Office Action Summary

10/574,858

NAKANO ET AL.

FRANCIS GARCIA

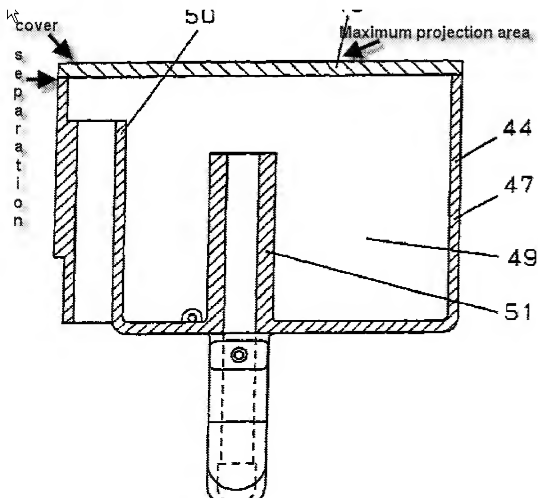
4. **Regarding claim 7**, Osaka discloses a hermetic compressor, wherein among a plurality of walls constituting said casing, a plate thickness of the wall in which the maximum projection area is obtained is thicker than plate thicknesses of the other plate thicknesses [Fig 3 attached on page 11].

6. **Regarding claim 11**, Osaka discloses a hermetic compressor, wherein a **lubricating oil** [46] is stored in said hermetic vessel, and at least one of walls of said casing of said suction muffler to which said lubricating oil is supplied is designed so as to have at least one of a configuration that it is thicker than the other walls of said casing and a configuration that it is higher in foaming magnification [Fig 3 on page 11].

7. **Regarding claim 12**, Osaka discloses a hermetic compressor, wherein the casing of said suction muffler has a suction muffler body and a **suction muffler cover** [48], and wherein a bonding portion between said suction muffler body and said suction muffler cover has a foaming magnification which is relatively lower as compared with portions except said-bonding portion, or it is not foam-molded [Fig 3 attached on page 11].
